START DATE: SEPTEMBER 2024	DUE DATE: <u>10-07-24</u>	TRC/STAFF Comments issued on: <u>10/08/2024</u>
-----------------------------------	---------------------------	---

LOCATION:	5109 MITCHELL MILL ROAD																																					
COUNTY:	WAKE COUNTY																																					
PARENT PIN:	1757571035																																					
DB/PG:	DB 8659, PG 954																																					
ZONING:	RM-CZ & NC-CZ																																					
TOTAL ACREAGE:	8,041,338 SF (138.89 AC)																																					
NC-CZ ZONE ACREAGE:	54.08 AC																																					
COMMERCIAL TRACT:	8.48 AC																																					
RESIDENTIAL ZONE RM-CZ:	84.81 AC																																					
MAXIMUM UNITS PERMITTED:	395 UNITS (134 TOWNHOMES)																																					
ZONING AND ANNEXATION:	MA 22-06 & ANX22-03																																					
TOTAL NUMBER PROPOSED LOTS:	83 LOTS																																					
MINIMUM PROPOSED LOT SIZE:	5,000 SF																																					
MAXIMUM PROPOSED LOT SIZE:	8,545 SF

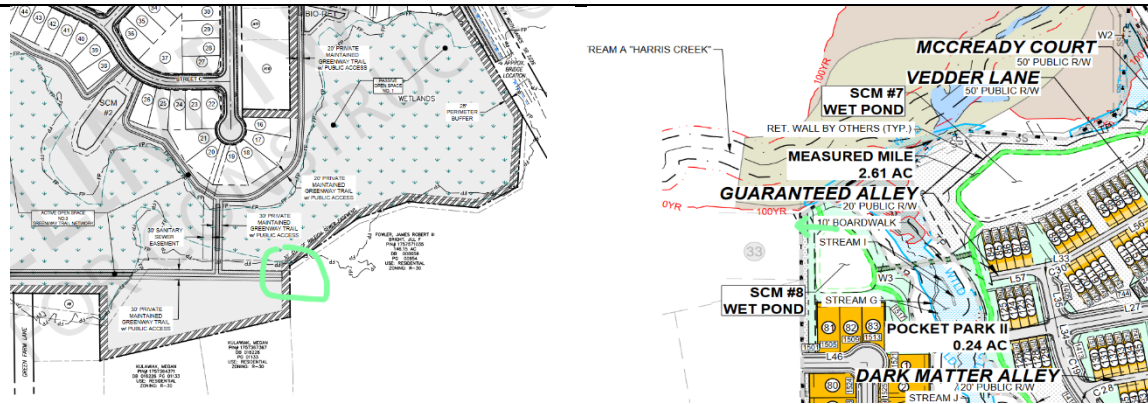
<p>Planning/Zoning - WithersRavenel</p>	<p>Comments are numbered. Applicant response to Version 4 comments are show in bold text and prefaced with “SREG RESPONSE:” . Planning comments on this (version 5) are shown in <i>red italic text</i> as “<i>WR Response:</i>”.</p> <p>Open spaces</p> <ol style="list-style-type: none"> For the NC-CZ district, in accordance with Table 3.4.3, permitted Open Space types are greens, commons, squares, and plazas. The applicant should demonstrate compliance with this requirement, understanding that future commercial areas will also need to comply with this requirement. <p>SREG RESPONSE: Open Space requirements and calculations have been updated, please see sheets C6.0 - C6.3</p> <p>Repeat comment: Comment is still applicable and has not been addressed sufficiently to determine compliance. Please label these areas on Sheet 6.0 and show detail drawings of each location, as needed.</p> <p>SREG RESPONSE: Greens, commons, squares, and plazas have been accounted for as types of open space on Sheet C6.0. There is also a tabular breakdown of active and passive open space on Sheet C6.1.</p> <p><i>WR Response: Open Space use types shown on the tabular breakdown do not match labels shown on sheets C5.0-.9. Please update plans to match.</i></p> <ol style="list-style-type: none"> Partial Site Plans VIII - The westernmost property line of the proposed site should provide a Mixed-Use Perimeter buffer as it separates the NC-CZ from the adjacent zoning, as outlined in Section 6.2.3. The first ten feet (10’) of this buffer is a Compatibility Transition Area 'A' and requires a minimum 10', landscaped buffer consisting of 1 canopy tree every 30 feet. Transition Area 'B' shall be a minimum of 10'. However, the plans should be revised to clearly show the correct buffers along this property line. NOTE: the MA 22-06

Concept Plan is only a conceptual plan of the project; it was not reviewed NOR APPROVED by the Town Board of Commissioners as a Preliminary Subdivision Plat. Further under LDO Section 3.3.B.2., “ conditions shall not lesser the standards in this LDO “ – the Town Board cannot and did not approve any type of lessening of or tacit variance from LDO subdivision requirements as part of the Rezoning approval. The Applicant has been reminded and made aware of how LDO Conditional Rezonings work and function multiple times; the response provided is wholly incorrect. Follow the comment and make corrections.

SREG RESPONSE: The adjacent property is classified as Wake County R-30. The correct Type 2 buffer is shown as approved by the Rolesville Town Council.

SREG RESPONSE: Section 6.2.3 and Table 6.2.2.2 outline the requirements of perimeter buffers within Rolesville jurisdiction. Since the adjacent property is classified as Wake County R-30, table 6.2.2.2 does not provide an applicable perimeter buffer requirement. A previously agreed upon Type 2 buffer is shown on the plans.

WR Response: Town of Rolesville Staff to provide direction.
